RE: Response to Public Comments Concerning the Harold MacQuinn, Inc.
Gravel Extraction Site Plan Review Application

**Hydrogeologic Assessment, prepared by Summit Environmental Consultants, Inc.
for Harold MacQuinn, Inc.**

PROJECT: KITTERIDGE PIT
 ROUTE 184
 LAMOINE, MAINE

SHEET TITLE: SCHEMATIC GEOLOGICAL CROSS SECTIONS

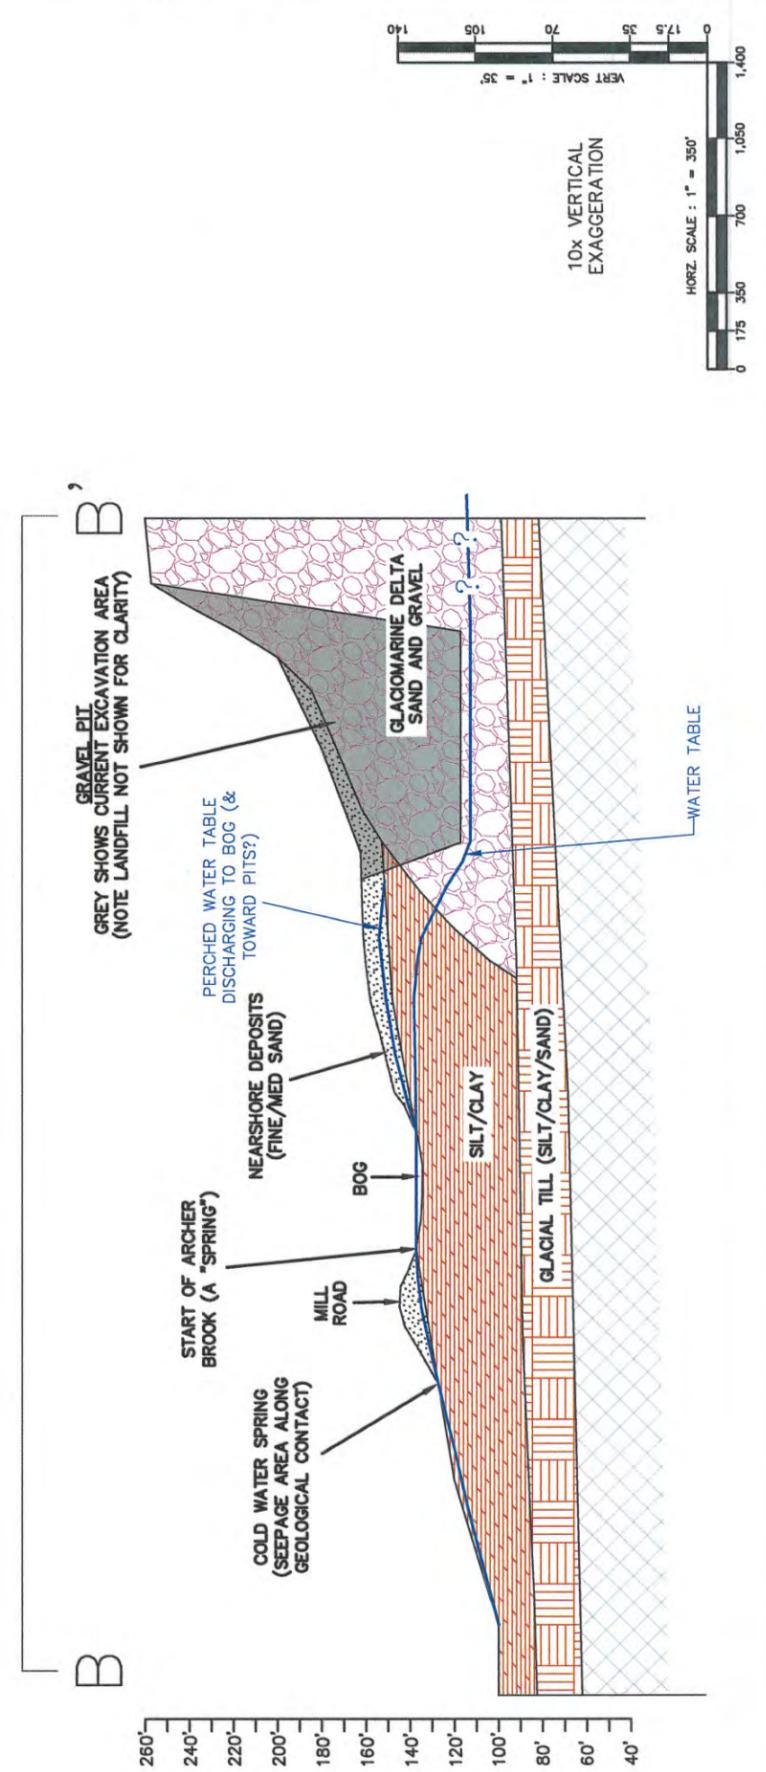
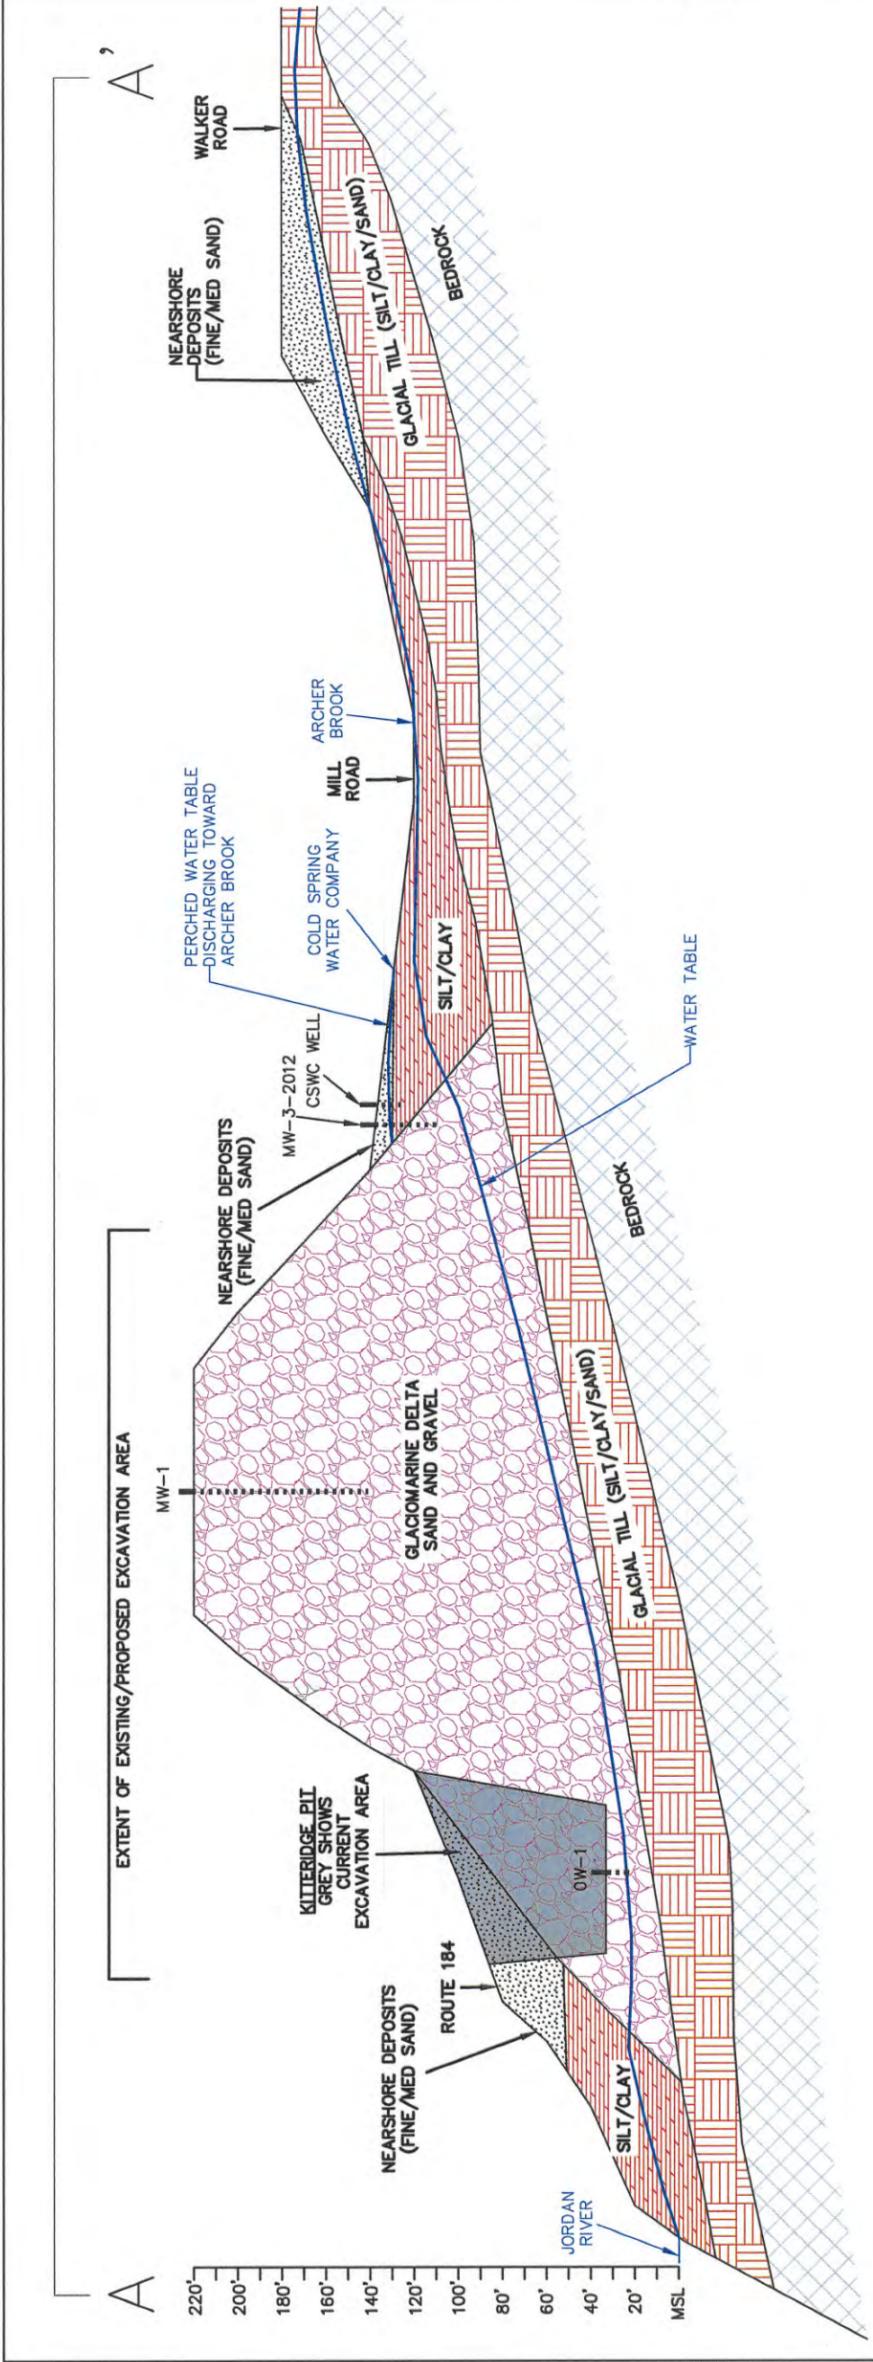
In this section Mr. Brutsaert states "Sections A-A' and B-B' are indeed schematic and do not reflect the boring logs information provided by...." And goes on to question the validity of Summit's cross sections and understanding to the hydrological setting.

Sections A-A' and B-B' are indeed schematic and do not reflect the boring log information provided by (incomplete) MW-1 and MW-3. There is no credible data to suggest an east to west slope of the bedrock topography, or a near horizontal north-south bedrock topography, let alone the "suggested" depth to bedrock. In order to establish a credible bedrock topography, any new observation wells must be drilled down to 'refusal'.

Worse is the position of the water table on that same A-A' cross-section, shown as a more or less straight line between OW1 and MW2 and sloping down from east to west.

3. Cold Spring is and has been a steady strong-flowing spring, also during periods of prolonged drought. If Cold Spring were fed from the south or by a 'perched' water table, as suggested on Cross-section A-A', flow would be intermittent, thus low flow or no flow at times of prolonged drought. Thus the flow of Cold Spring is as explained in point 1 of this discussion.

Geologists have spent the last two centuries examining present-day depositional environments and applying that information to understanding the environment in which older deposits were formed (i.e.; the key to the past is in the present – Principle of Uniformitarianism). Based on studies of current depositional environments, geologists have found that gravel, sand, silt, and clay deposits are formed in drastically different depositional environments. Gravel is deposited in high energy environments (streams and rivers). Silts and clays are deposited in low energy environments (deep water ocean/lake environments). Sands are deposited in the intermediate depositional environments (river/stream delta, near shore environments and beaches). The other key geological principle used to interpret subsurface geology is the law of superposition (or the principle of superposition), which states that sedimentary layers are deposited in a time sequence, with the oldest on the bottom and the youngest on the top.

Summit prepared the schematic geological cross sections presented at the Planning Board meeting based upon the MGS maps; field reconnaissance in former and active gravel pits to the south of Mill Road; and surficial materials and ground water elevations information from monitoring wells installed on the Site and former/active gravel pits locate to the south of Mill Road; as well as the elevation of the seepage areas associated with Cold Spring. The relationships between geological units and water table elevations presented on the cross sections serves as a visual representation of what is typically referred to as a hydrogeological conceptual site model.

Cold Spring is located approximately 1,000 feet beyond the eastern extent of the proposed gravel pit excavation and is located in a separate and distinct hydrogeologic setting. As previously discussed, the Presumpscot Formation was deposited after the stream/delta sediments were deposited, therefore the silt and clay layer (Presumpscot Formation) can not extend into the delta deposits, and instead was deposited around and lapping against the delta/stream deposit. Summit's cross sections and MGS maps clearly show this relationship.

The geological cross sections with monitoring wells shown have been included with this response letter to better depict this relationship to the Planning Board, as it is apparent that Mr. Brutsaert could not glean this fact from the information presented to the Planning Board.

The generalized bedrock surface shown on Summit's cross sections is based on the typical Peninsula setting common along coastal Maine and is consistent with basic principles of glacial geology. However, it must be noted that the bedrock surface depiction is irrelevant to the hydrogeologic setting associated with Cold Spring and the proposed gravel pit.
